northern
beaches
council

PRELODGE MENT ADVICE

Application No: PLM2019/0280

Property Address: Lot 7335-7336/1152473 Hakea Avenue FRENCHS FOREST

Figure 1. Building height variation highlighted in blue when viewed from the east (area adjoining the residential zone).

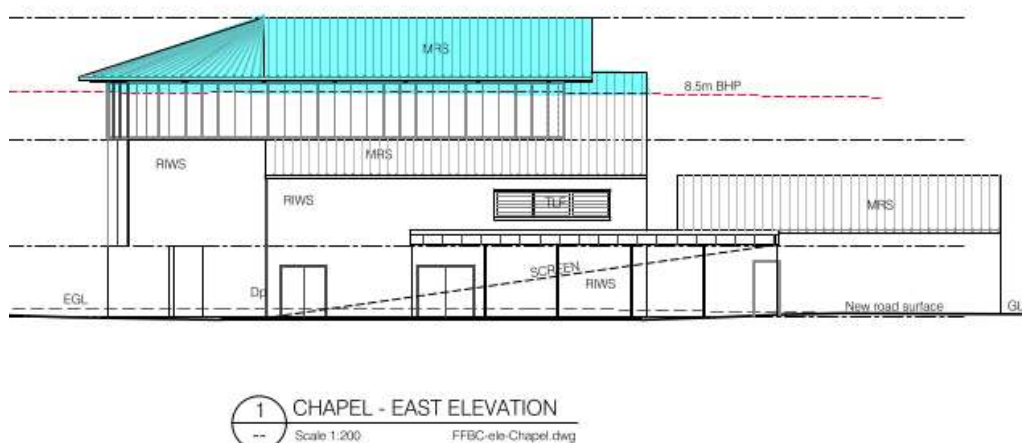
There is a large portion of the chapel proposal above the 8.5m height limit. The building height exceeds the 8.5m development standard at 11.69m for the upper glazed area and roof line over the whole of the chapel.

The proposed building height of 11.69m is a significant departure from the Building Height Standard, and may create unreasonable visual dominance to the surrounding residential area.

However, the building height is inconsistent with the streetscape and the character of the adjoining residential area. The non-compliant building height does not relate to any natural constraints of the site (such as significant slope), and has the potential to give rise to unacceptable amenity and visual bulk impacts to the surrounding residential dwelling houses.

There has been no attempt to minimise the bulk and scale and further refinement could be undertaken to reduce the overall building height and balance the architectural design in sympathy with the nearby residential neighbours.

Any future application must address any building height variation and the quantum of the impact within The Statement of Environmental Effects.

It is also recommended that Photo Montages, from multiple angles be incorporated to demonstrate any visual impact of the proposed Chapel.

A comprehensive Clause 4.6 Variation to the Building Height, along with a detailed Design Statement, must also be submitted to clarify and establish how the location and high architectural merit and its intentional purpose of the building balances with the planning controls and the nearby residential area.

Figure 2. Demonstration of proposed front setbacks.

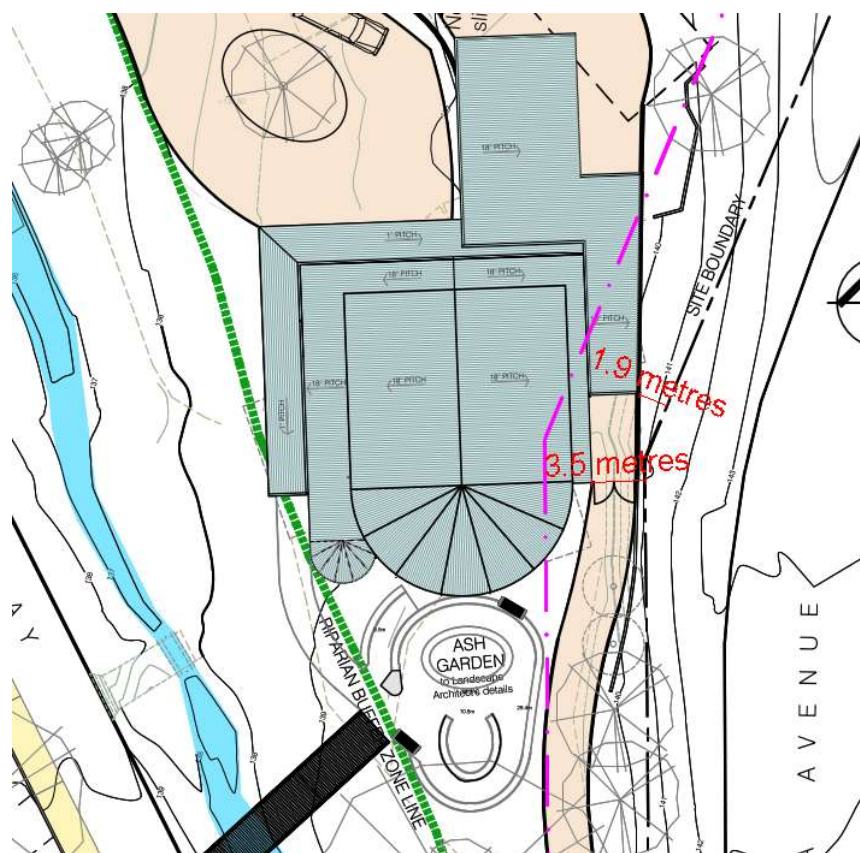
It is acknowledged that the siting of the proposed chapel is dictated by the constraints of the site, being the location of existing and future interments, stormwater channel, established native trees, riparian zone and the location of existing buildings.

Therefore, due to these constraints of the site, the available location of the Chapel creates a variation to the 6.5m front setbacks, being 1.9m – 3.5m, as shown below.

However, these setback could be supported providing demonstration that the non-compliant setbacks do not cause amenity impacts to the eastern residential dwelling neighbours, particularly the dwelling houses on Hakea Avenue that adjoin the boundary.

It is also recommended that any future proposal should include an increase in the landscaping within the curtilage of the front setback adjoin the Chapel considering the significant increase in height, bulk and scale.
